Field Modification Tracking Table

Field Modification / Construction Bulletin Form	Date (dd/mm/yyyy):	07/31/12
Lower Passaic River Project, Phase I Removal	FM # or CB # (FM - ### or CB - ###):	CB-001
ARCADIS	Revision (##):	0

Lower Passaic River Project

TIERRA SOLUTIONS, INC. • LOWER PASSAIC RIVER, NEWARK NJ
PHASE I CERCLA NON-TIME-CRITICAL REMOVAL ACTION
OU-1 FLOODWALL TIEBACKS WALE MODIFICATIONS - (1 OF 3)

SEDIMENT PROCESSING SITE PLAN

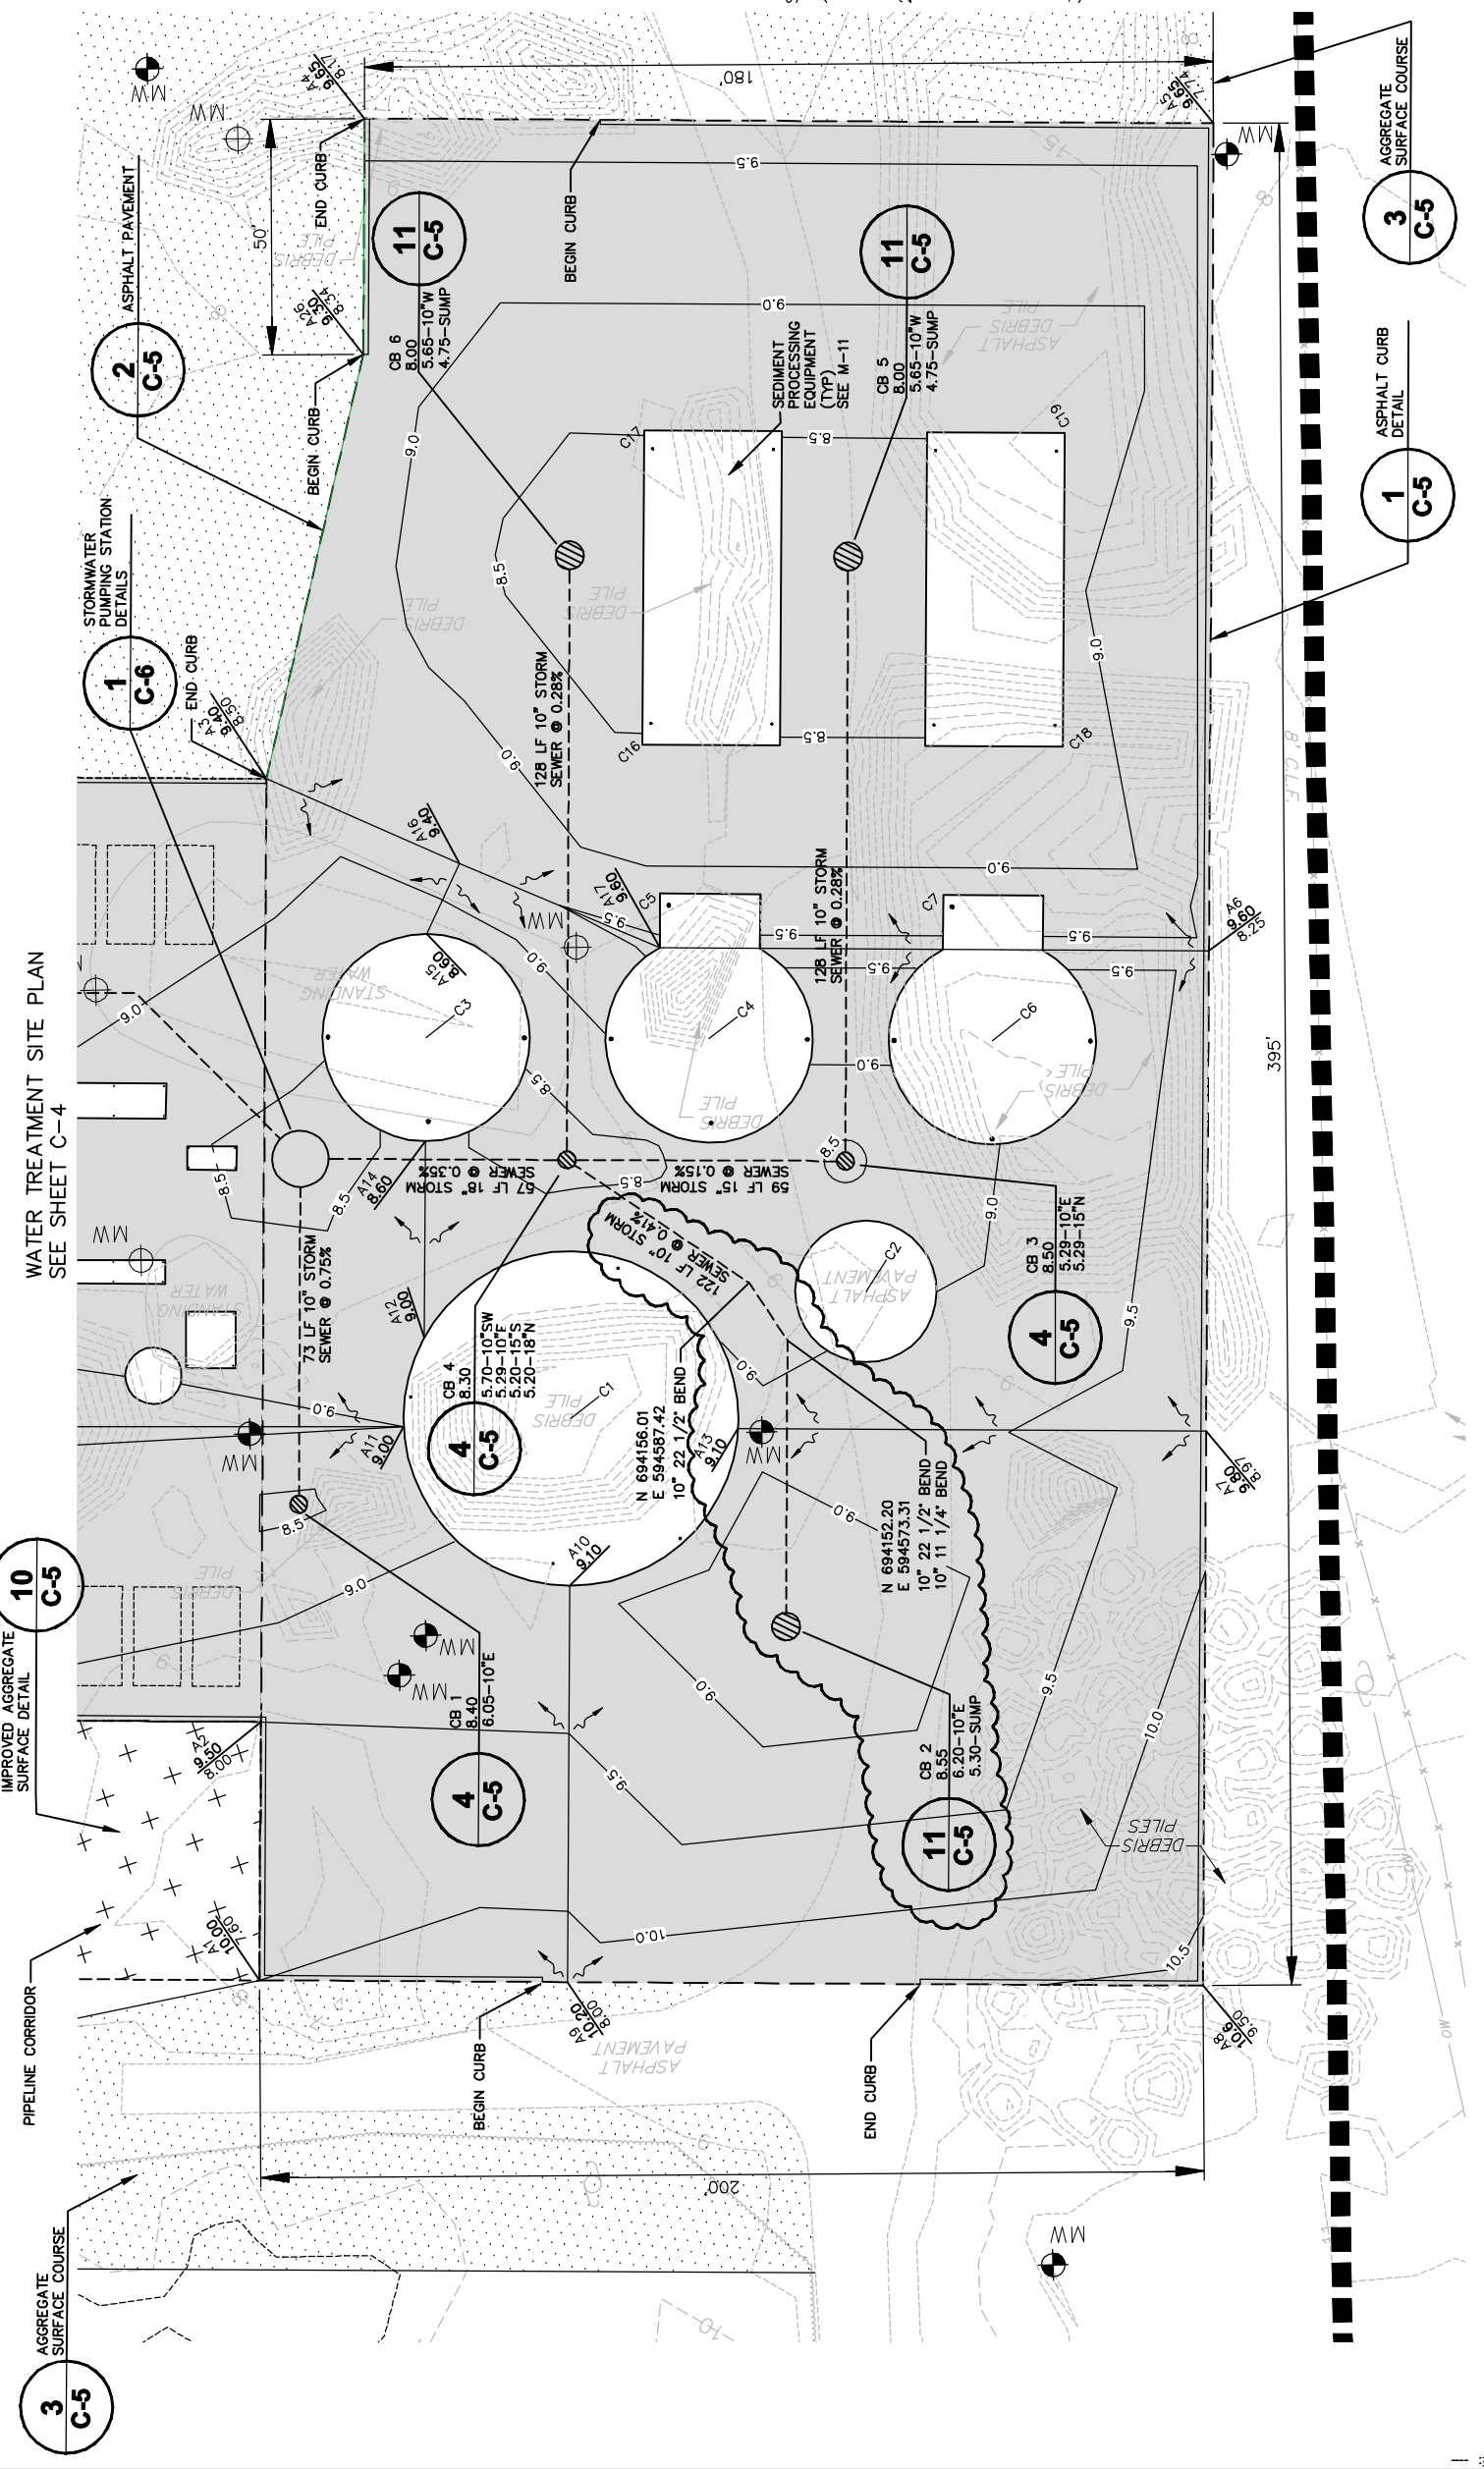
<u>Design Coordination and Documentation</u>		Date
Are sketches detailing design modifications attached to FM?	<input checked="" type="radio"/> Yes / <input type="radio"/> No	8/29/2011
Are existing drawings required to be updated, sealed and re-issued? <small>(note - as-built drawings will be issued after construction and will incorporate FM)</small>	<input type="radio"/> Yes / <input checked="" type="radio"/> No	
Do the specifications need to be modified?	<input type="radio"/> Yes / <input checked="" type="radio"/> No	
Specific drawings and/or specification sections and paragraphs affected: <u>Revised catch basin CB-2 location on drawing C-3</u>

PROJECT MANAGER Approver	DEPARTMENT MANAGER Checker	LEAD DESIGN PROF. Designer	CHECKED BY Checker
SHEET TITLE PASSAIC ENCLOSURE WEIR WEIR SEAL 8/31/2011		TASK/PHASE NUMBER	DRAWN BY Author
		PROJECT NUMBER Project Number	DRAWING NUMBER W2

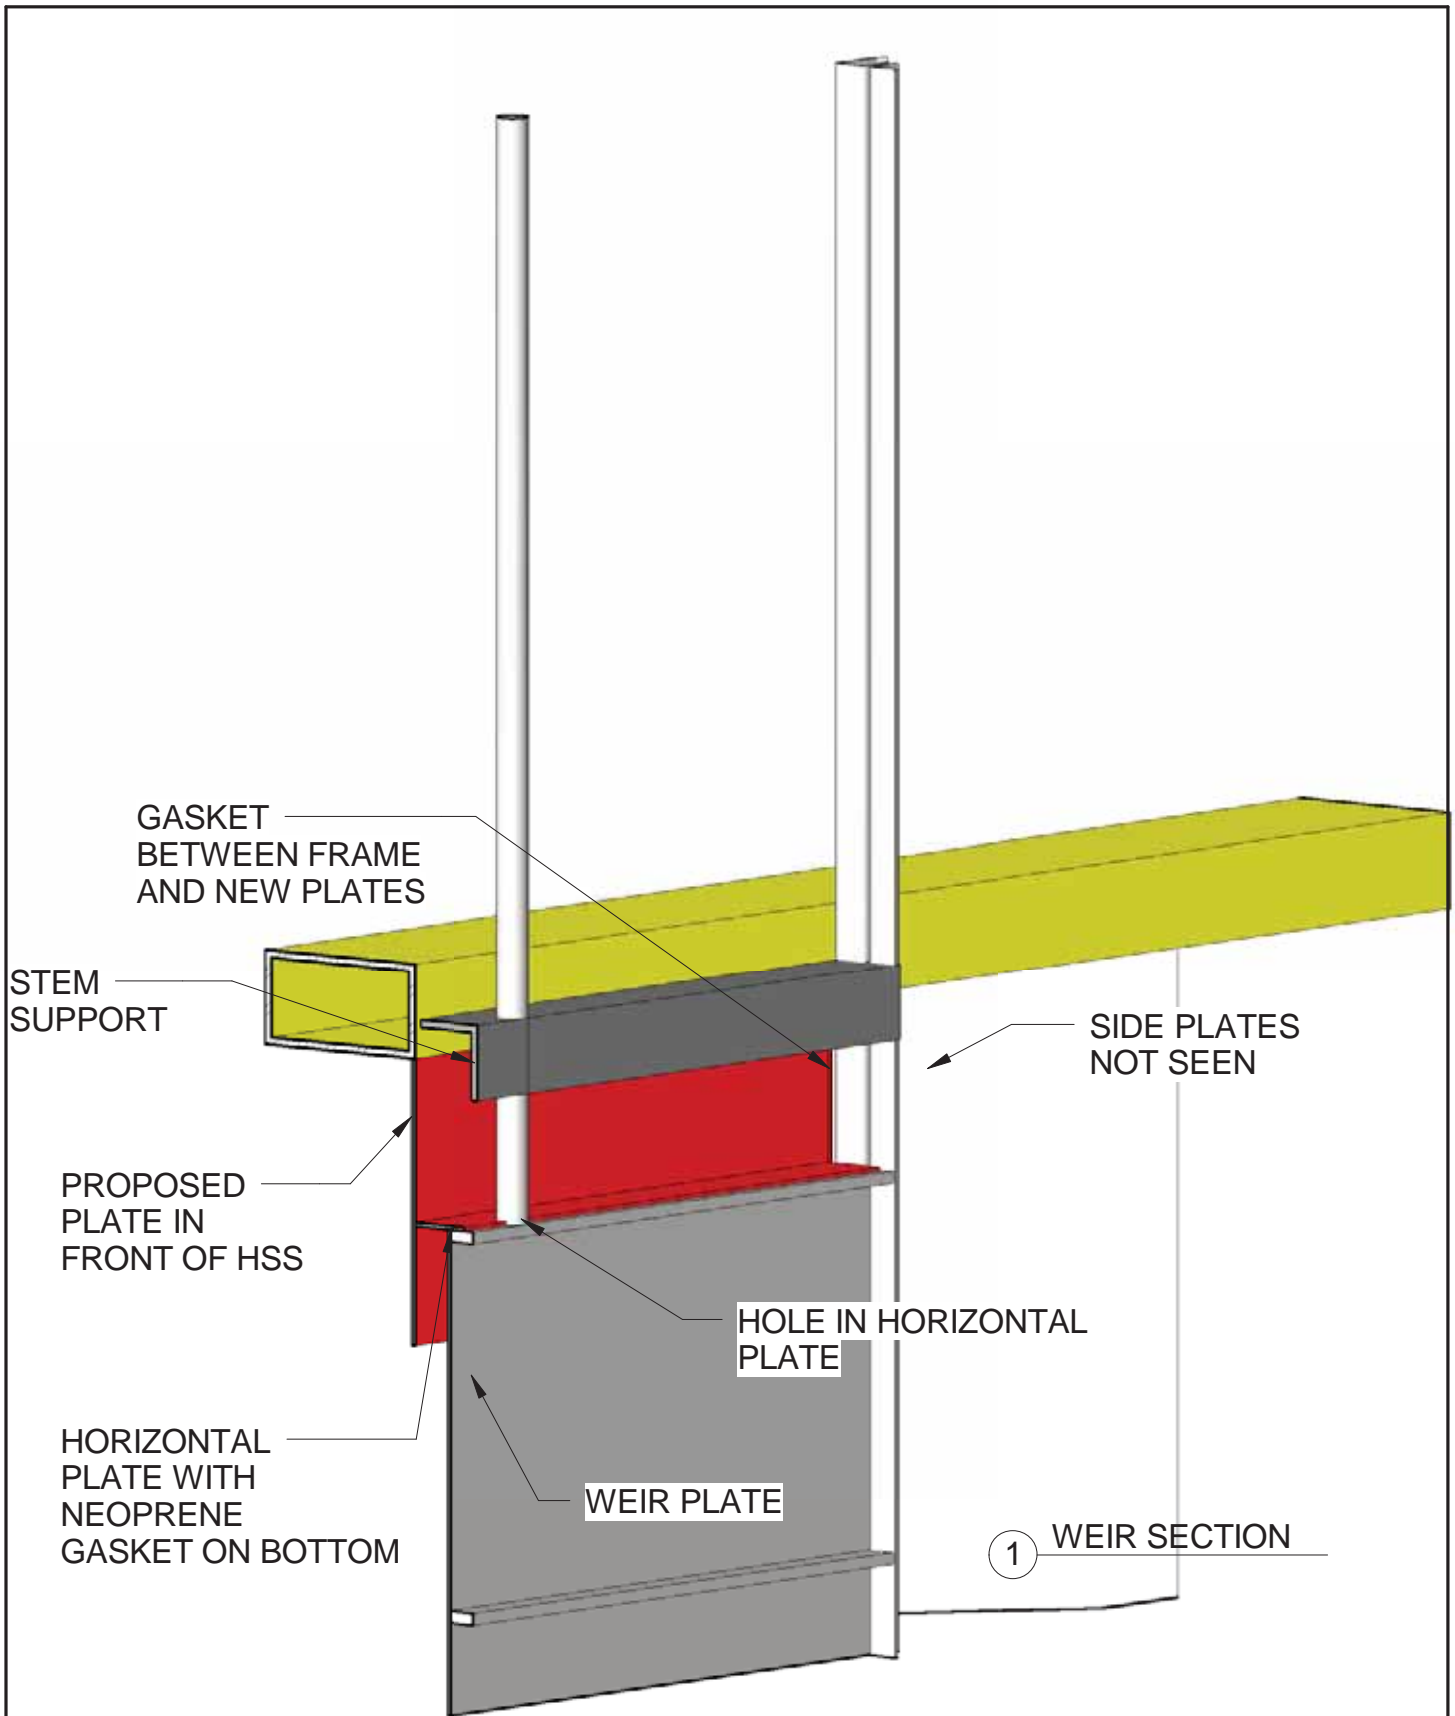
Reason for and nature of modification:
 Water within the enclosure will need to be managed by lowering the existing weir gate by one foot to allow water to enter into the enclosure during the winter, when pumps are not yet mobilized to the site. The current weir gate design was not anticipated to allow water in during high tide, and water is expected to leave the enclosure due to infiltration. Therefore water will need to be maintained within the enclosure. Lowering the weir gate by one foot resulted in several changes to the current weir gate design which are provided in the attachment to this Field Modification.

The two (2) vertical W18X35 will be extended one (1) foot instead of extending a temporary plate above the W18x35. A 1/8" steel plate will be welded to the HSS and the W18X35. Finally, a 1/8" steel plate will be welded perpendicular to the weir gate as shown in the drawing.

Subject: Pipeline New Location

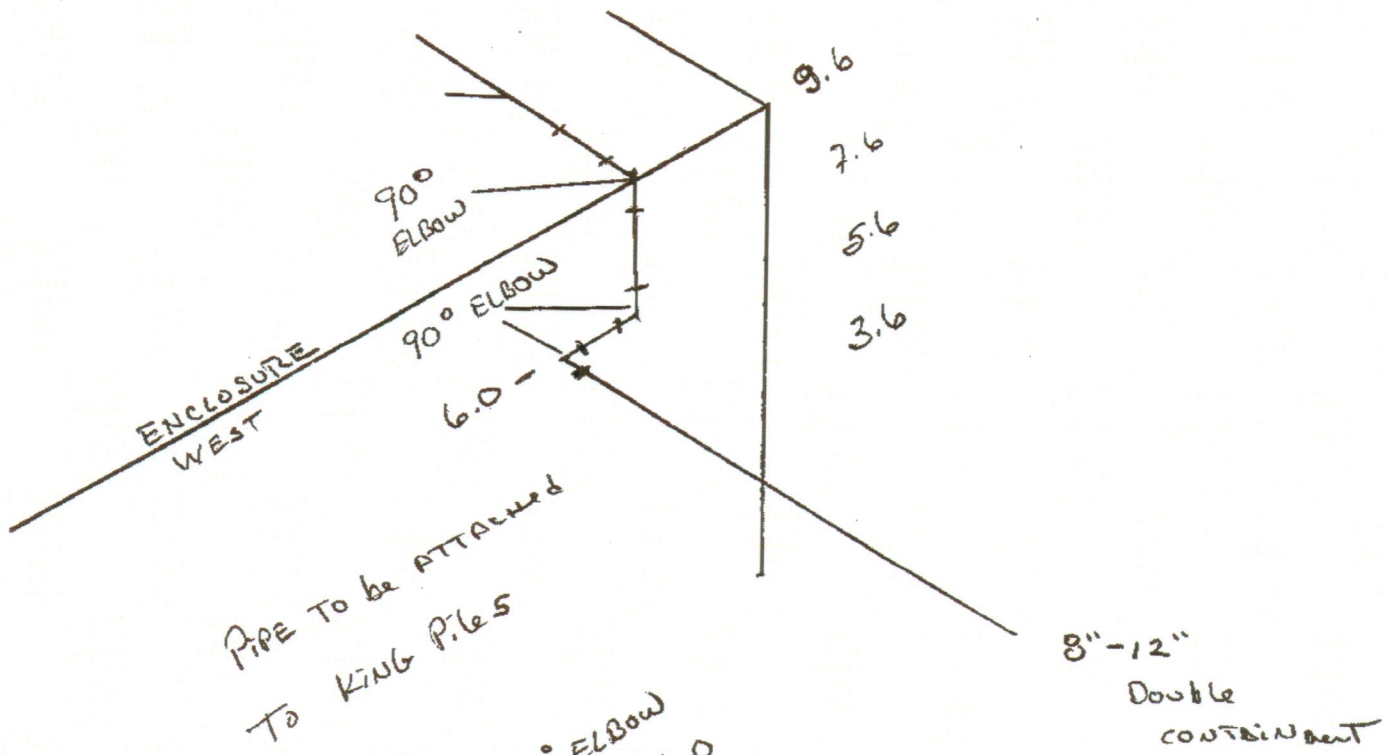
The flexible connection at the connections to the floating pipeline at the Phase I Work Area and at the UPF may not form a secure seal between the sections of HDPE piping. As an alternate to a flexible connection, Weeks will adjust the routing of the dual containment piping from the enclosure to the floating section (see attached sketch), and Weeks will provide sufficient slack in the pipeline for tidal fluctuations where the floating pipeline transitions from floating to fixed connections.

This submittal is a complement to RFI 014. The double containment pipeline will not have the felxibel joint but will be re-directed as shown on the isomtric drawing attached.
